**Service Bulletins
January 1979 to
September 1986 inclusive**

**Rolls-Royce Silver Shadow
Long Wheelbase,
Corniche and Camargue
Bentley T Series and Corniche
Rolls-Royce Silver Shadow II
and Silver Wraith II
Bentley T2**

ALL ROLLS-ROYCE FRANCHISE HOLDERS
SERVICE BULLETIN INDEX FOR TSD 4318

Fig. 3 Assembly of aerial for Silver Shadow II, Silver Wraith II and Bentley T2 cars

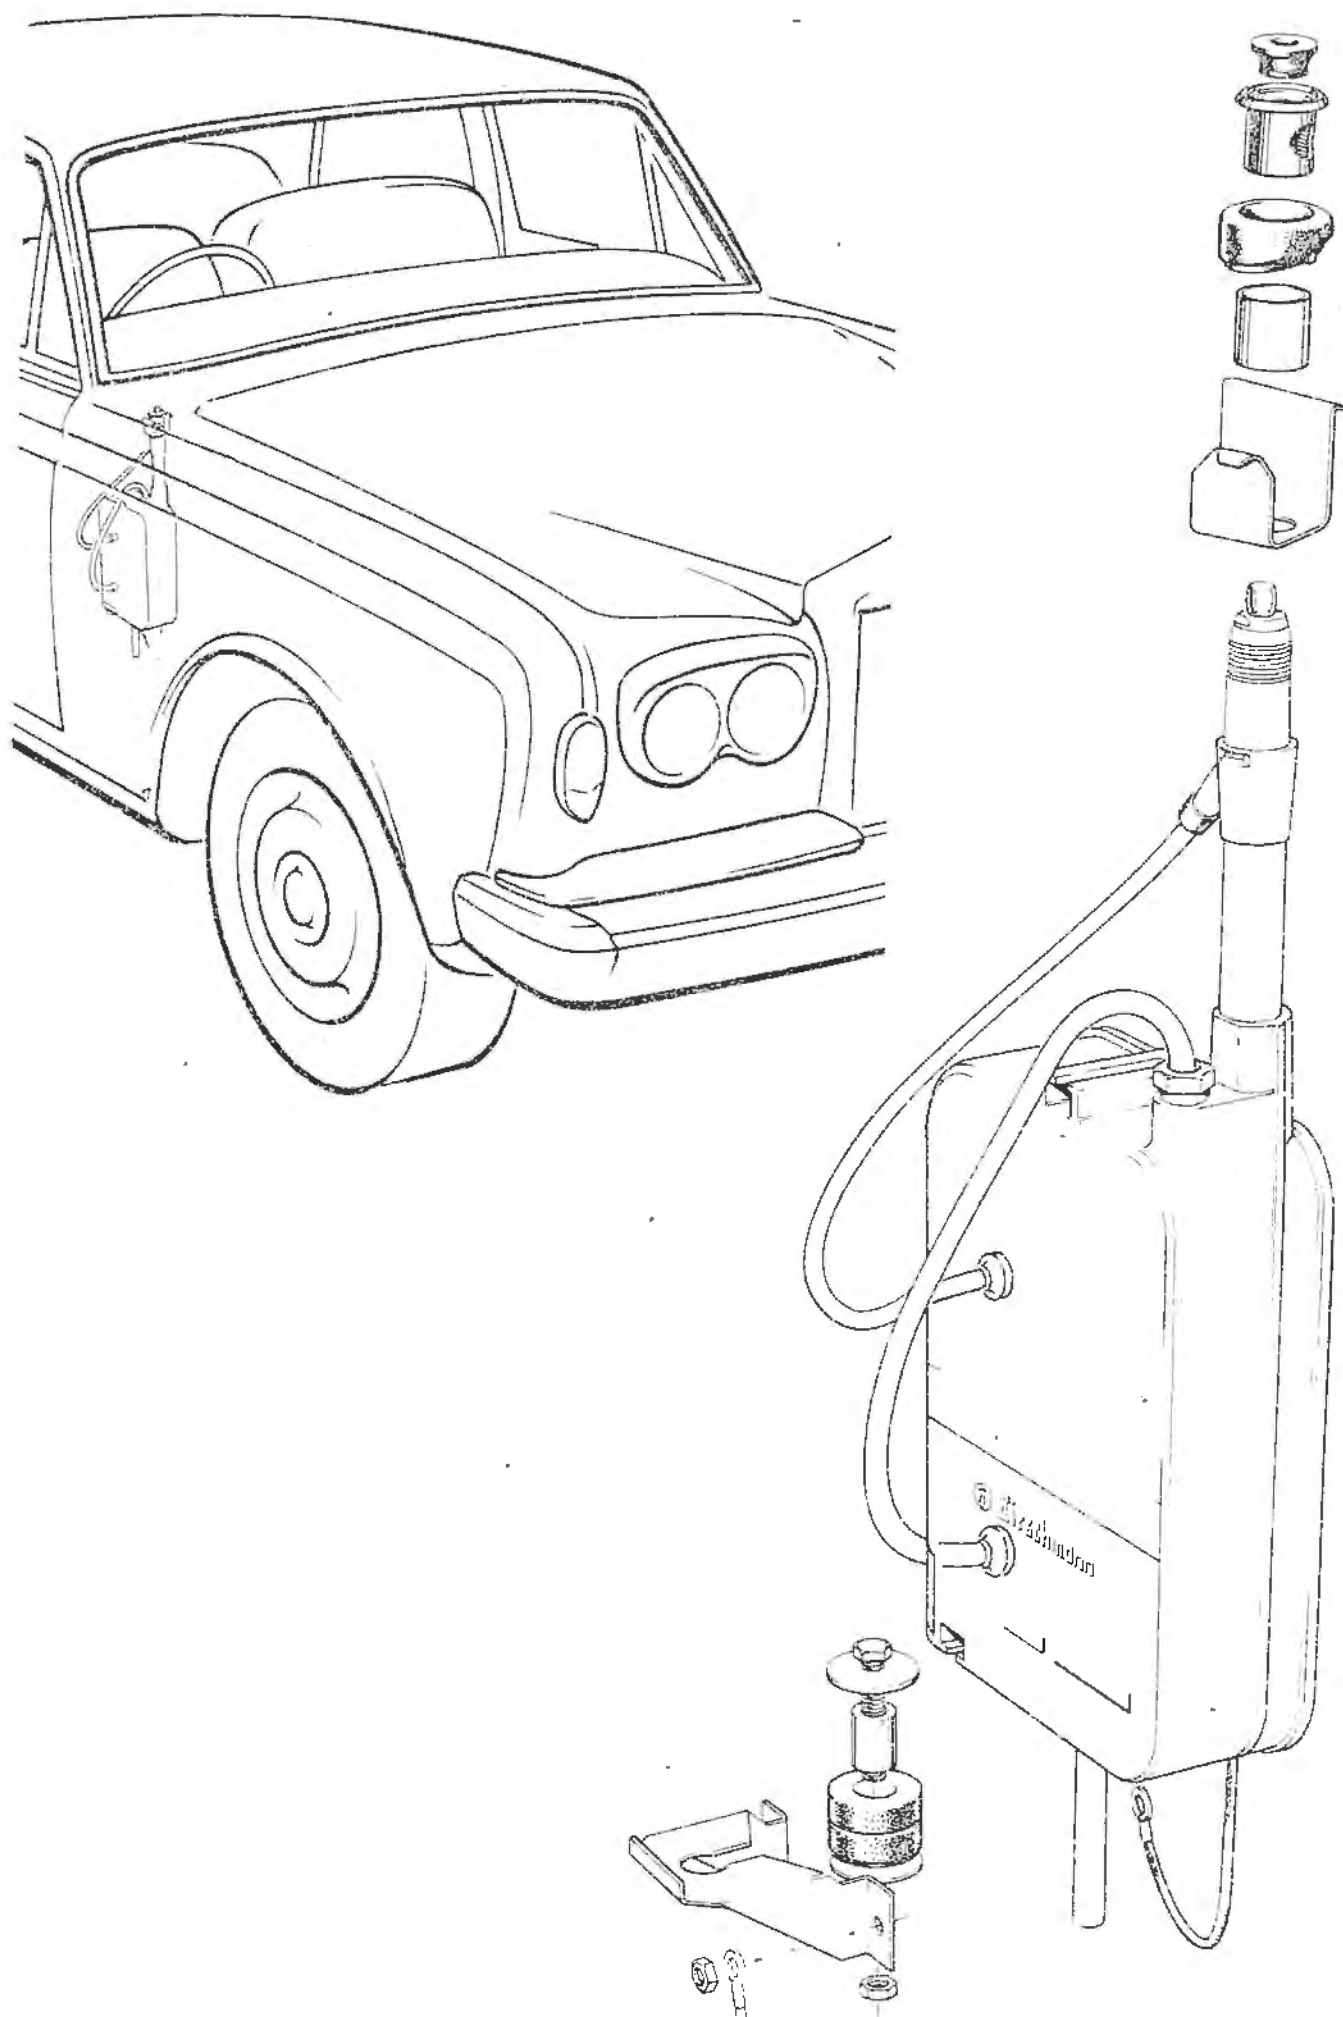
7. Fit the new aerial, as shown in Figure 3 for four door cars or Figure 3A for two door cars.
8. Connect the new aerial to the existing wiring.
9. Replace the coaxial aerial lead with the new type from the kit of parts.

Radio aerial switch and wiring

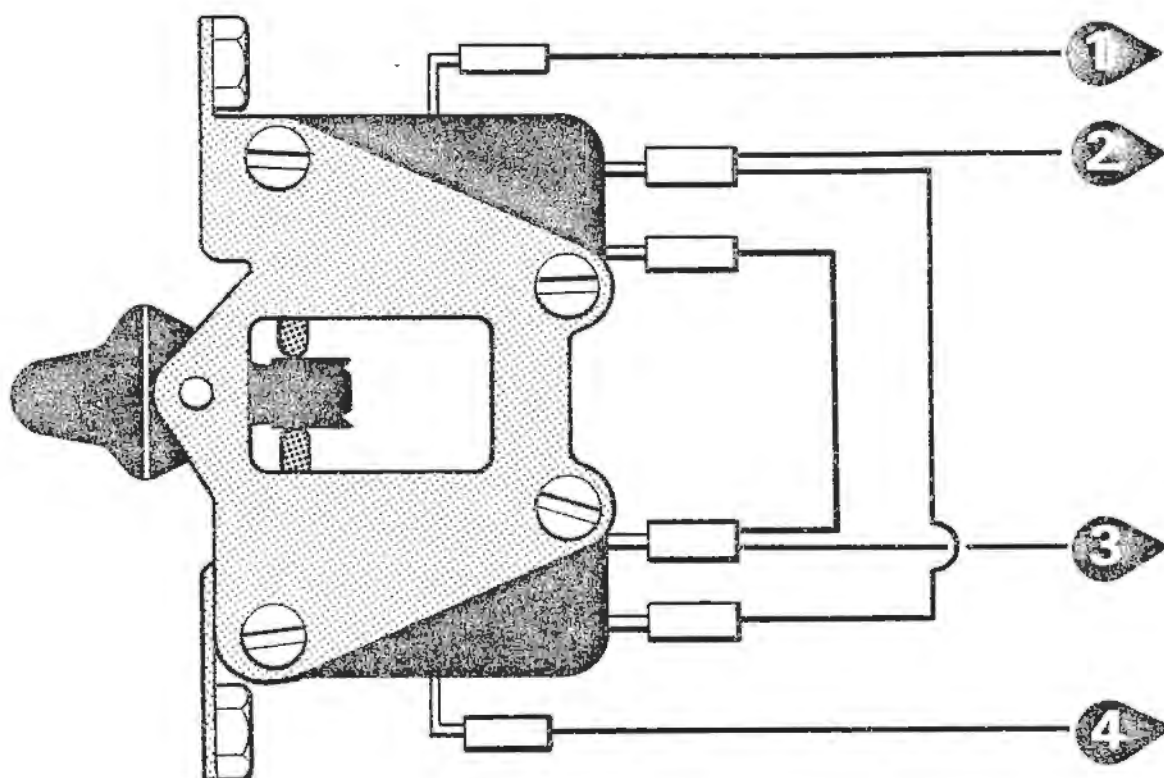
10. Remove the radio aerial switch.
11. Ensure that the micro switches that make up the aerial switch are of the three terminal type, as shown in Figure 4. If not, replace the micro switches with the three terminal type from the kit of parts.

12. Make up a length of 14s Black cable to run from the aerial switch to a convenient earth point.
13. Reconnect the aerial switch wiring including the new length of Black cable, as shown in Figure 4.

Fig. 1 Revised UD 25279 Control Box

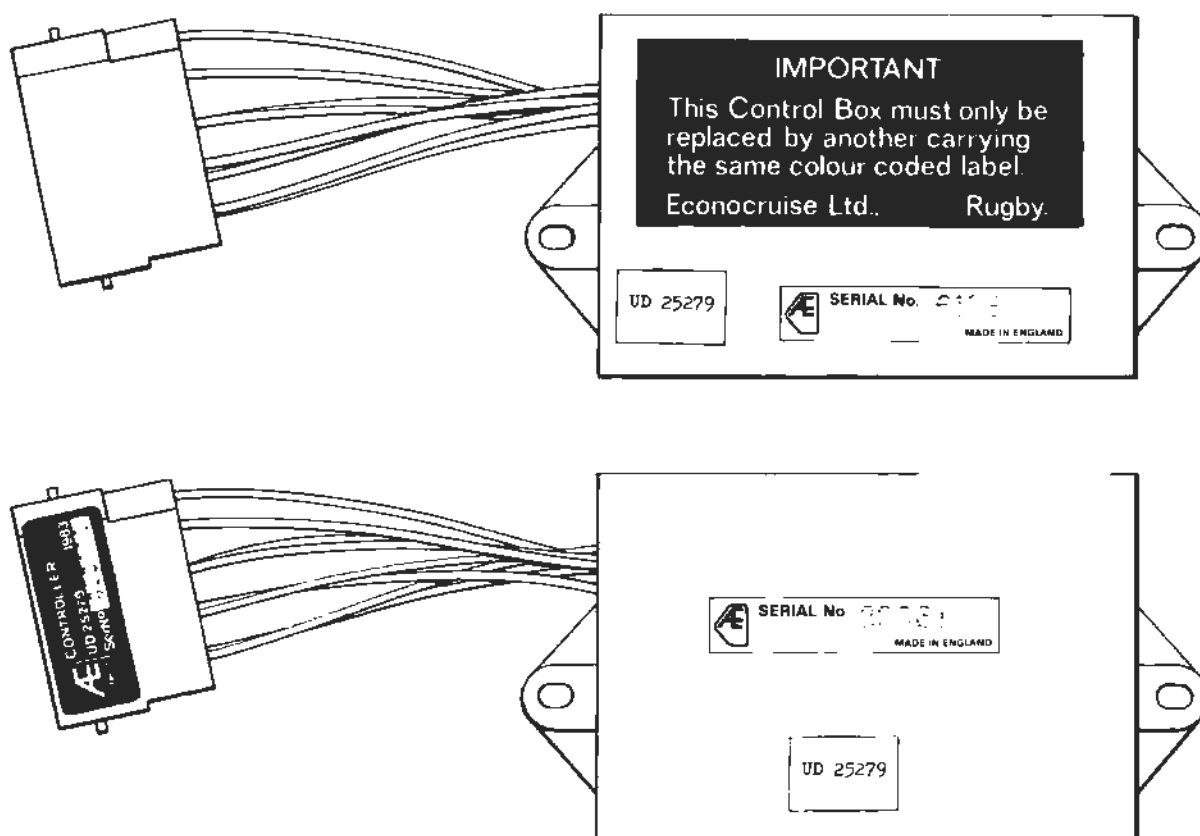
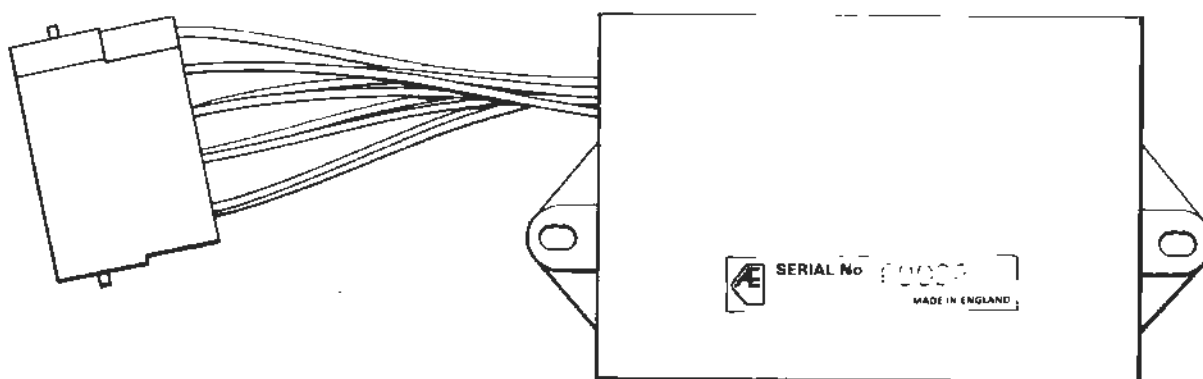
The revised control box can be recognised by additional identification labels which have been affixed onto either the black plastic case or the 9-way connector moulding as shown in figure 1.

Fig. 1 Shaping the peg

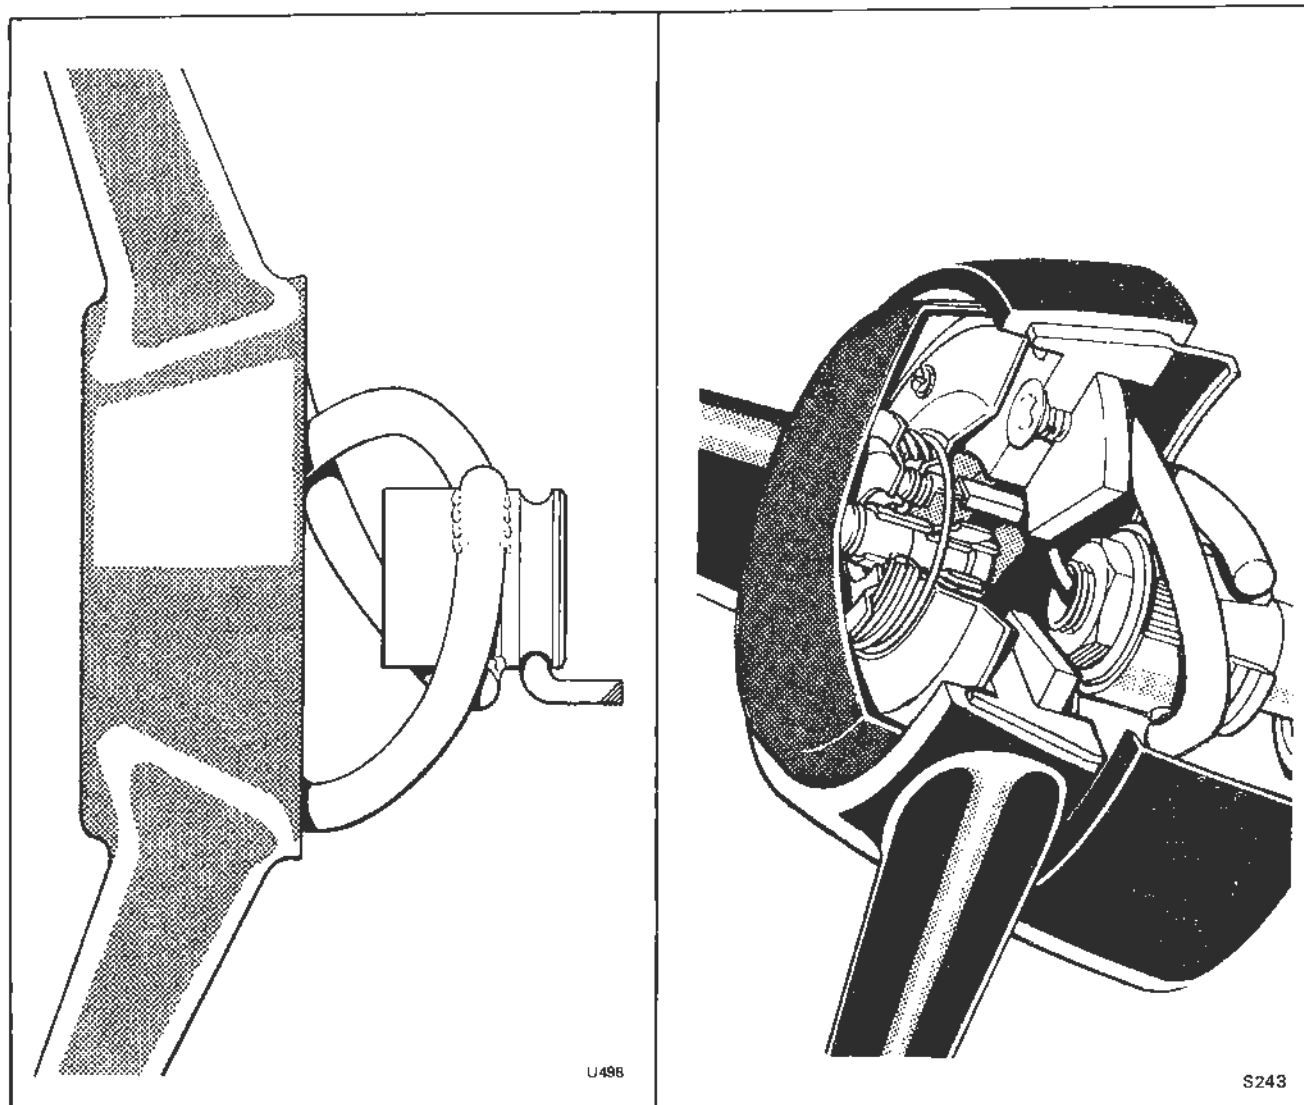
8. Position the steering wheel onto the column and tighten to the correct torque. With LOW selected on the gear change quadrant check that the indicator cancelling peg does not foul the selector lever. If a foul does occur, remove the wheel and shape the peg as shown in Figure 1 so as to ensure a clearance. Re-fit the wheel and again check that the peg clears the lever.

FIGURE 1

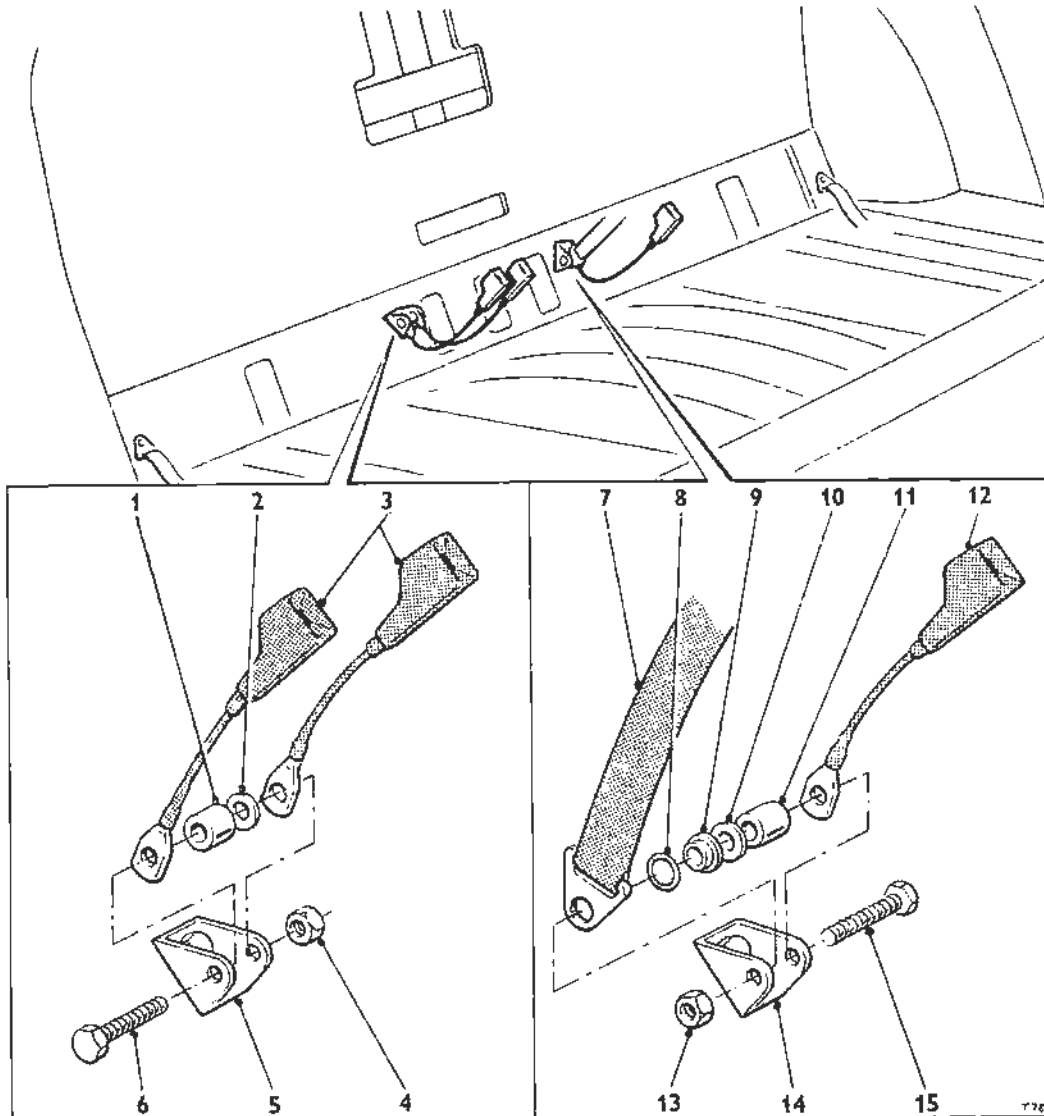
- 1 Contact the customer and arrange for the following work to be carried out.
- 2 Remove the rear seat cushion.
- 3 Remove the seat belt stalks, washers and spacers from the two centrally positioned anchor brackets shown in Figure 1.

FIGURE 4

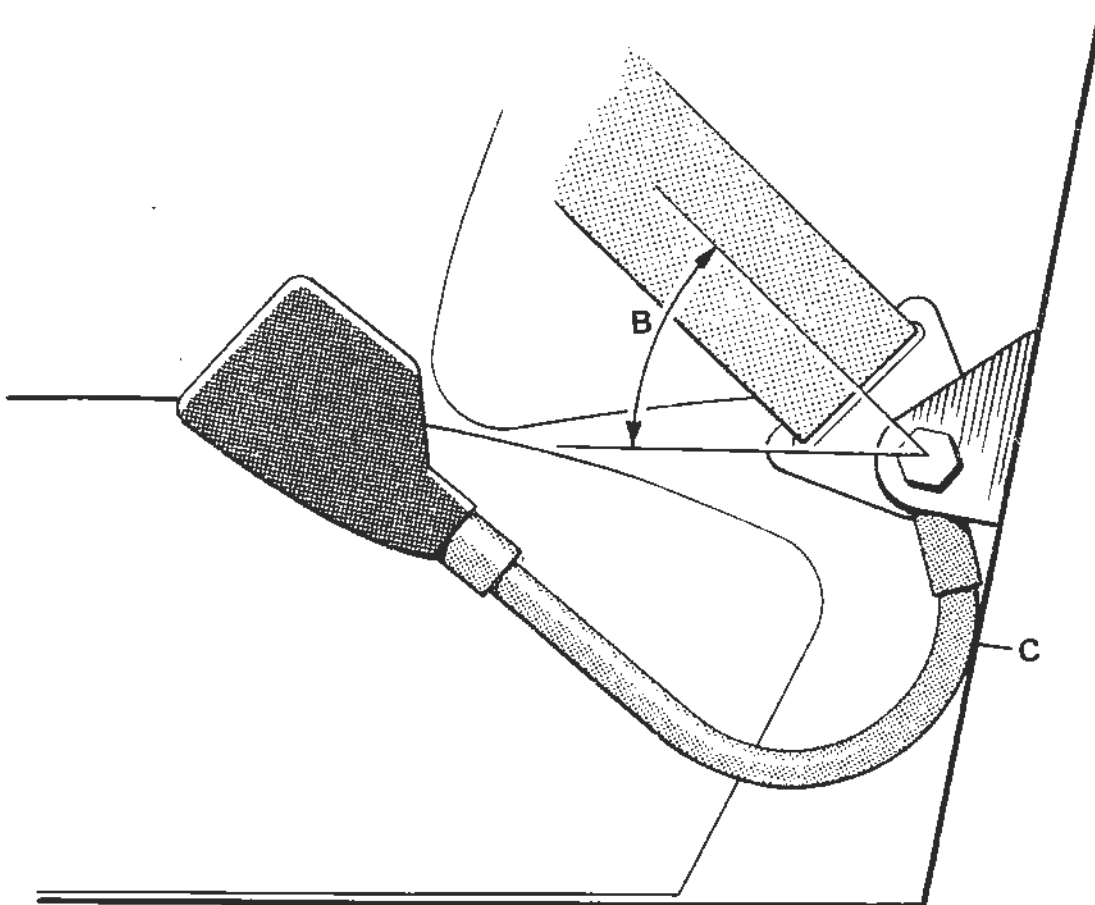
NOTE: This will be made easier if the armrest is partially lowered.
- 4 Remove the two anchor brackets.
- 5 Fit the replacement anchor brackets ensuring that they are positioned at the correct angle as shown in Figure 3.
- 6 Using the new nuts and bolts and the plain washer, provided in the RH 2768 kit, loosely reassemble the seat belt stalks, spacers and washers etc., in the positions shown in Figure 1 or 2 as applicable.
- 7 Set the positions of the seat belt stalks in the right-hand bracket as shown in Figure 4. Ensure these positions are maintained and torque tighten the nut to between 25-30 lbf.ft. (3,4-4,1 Kgf.m.).
- 8 Set the position of the seat belt stalk in the left-hand bracket as shown in Figure 4 and position the lap belt anchor plate to the correct angle as shown in Figure 4.

CORNICHE SALOON DOOR SHUT
FIG 1

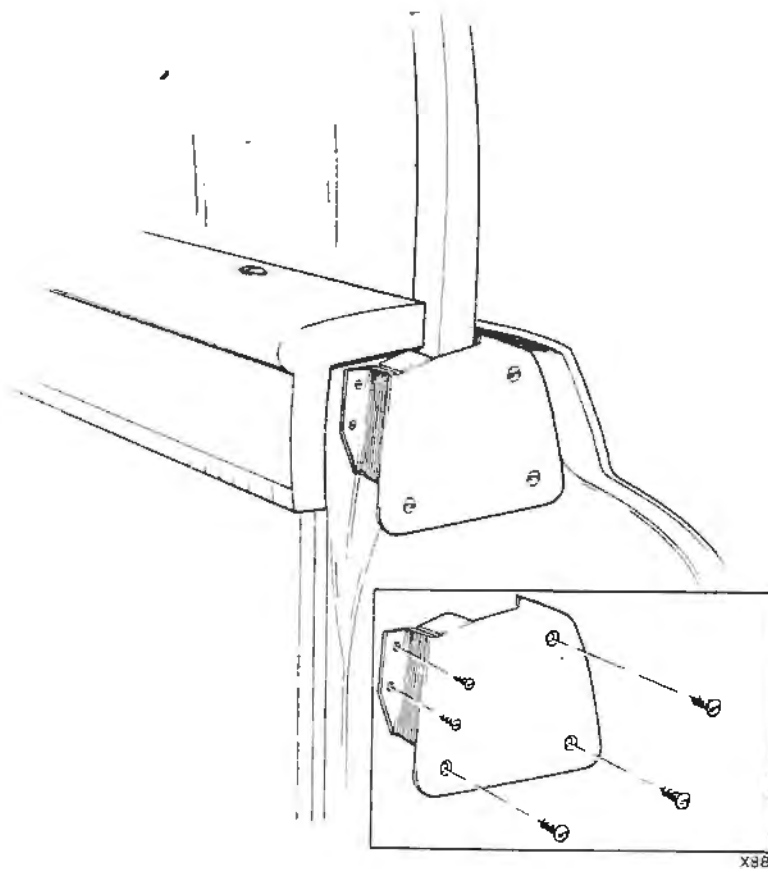
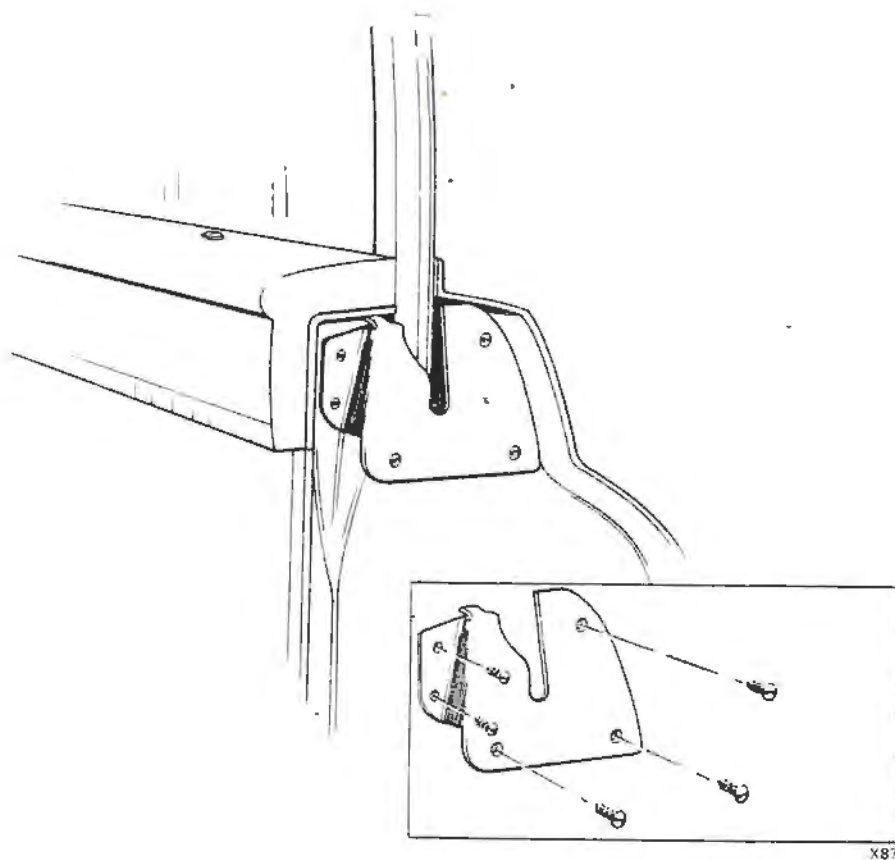
Secondly, to improve the strength even more in these areas a stainless steel capping finisher is also being fitted as shown in Figure 1.

8. Rebuild the door.
9. Position the stainless steel capping finisher on the shut face. Secure with the self-tapping screws as shown in Figure 1.
